Stormwater Division

General File ID or BMP ID: CC035

Williamsburg Landing

Project Name: WILLIAMSBURG LANDING
Structure/BMP Name: BMP-3 / BASIN #3
Project Location: BERKELEY MAGISTERIAL DISTRICT - OFF LAKE POWELL ROAD NEAR INTERSECTION OF BROOKWOOD DR.
BMP Location: BETWEEN DOW LANE AND DOWNING STREET ON THE NE SIDE OF THE MALL
County Plan No.: SP - 017 - 02

LOW FLOW STRUCTURE DETAIL FOR
 SHEET PILE WALLS
WILLIAMSBURG LANDING, INC.
 JAMES CITY COUNTY, JAMESTOWN DISTRICT, VIRGINIA

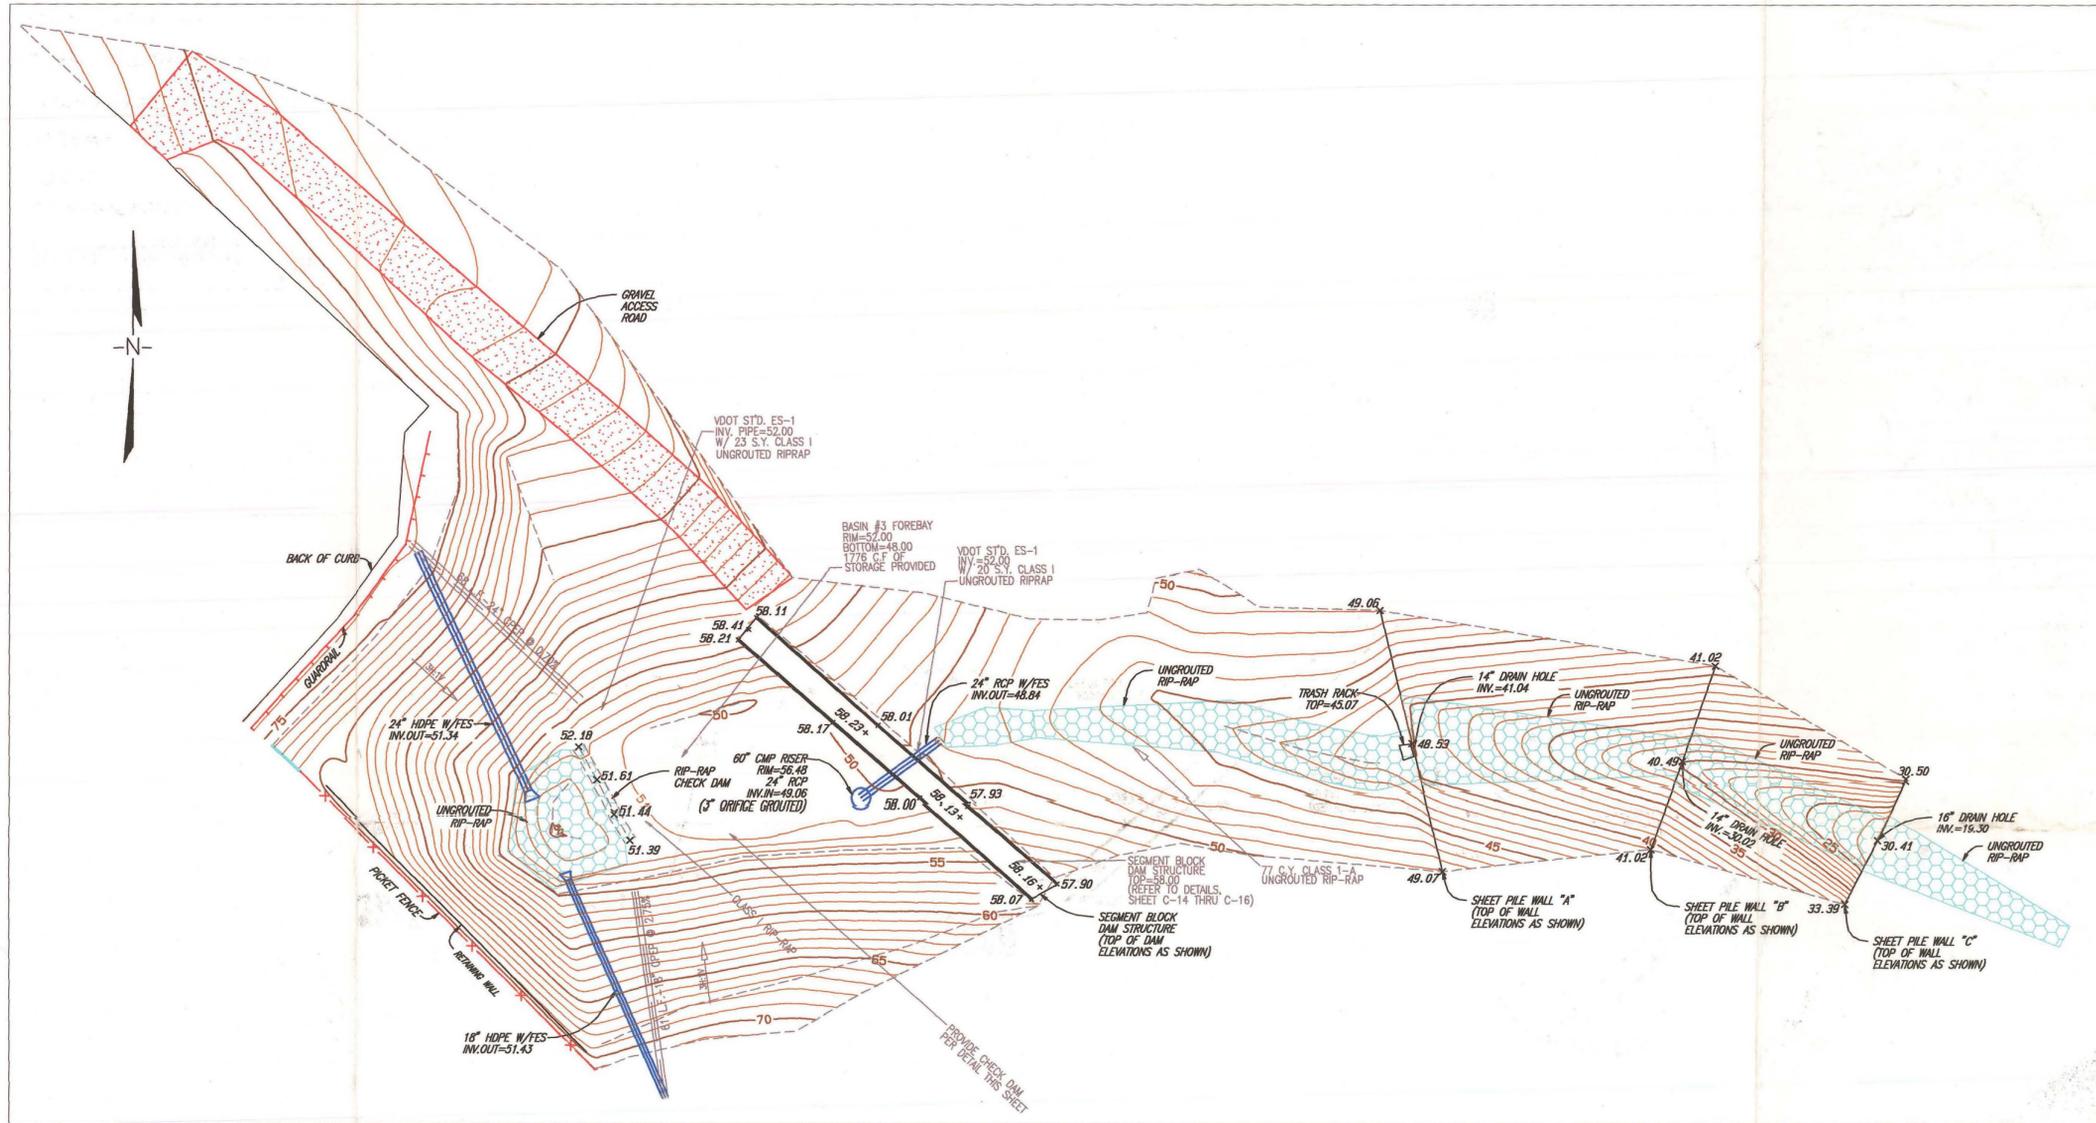
We received revised plans on 4/26/11 and they look acceptable. The height of the 4' pipe should be consistent with the elevations of the original structures.

The 48" half pipe should be installed with a bottom elevation that is deep enough to prevent the stormwater flows from entering underneath the pipe, and exiting through the sheet pile orifice, thereby short circuiting the perforated pipe system.

1. Yes, we plan to have A1 riprap over the top of the filter cloth wrapped stone.
2. I understand the issue of clogging. A similar design is used at the BMP on the east side of the Woodhaven Building at Williamsburg Landing and it has worked very well with minimal maintenance. With upstream areas primarily stabilized, we feel that this can work.

3. The bottom of the 48" half pipe will be buried at least 2 feet below the invert of the orifice in the sheet pile wall to help stabilize it. A1 riprap will then cover that fill material so I believe this will prevent the short circuiting.
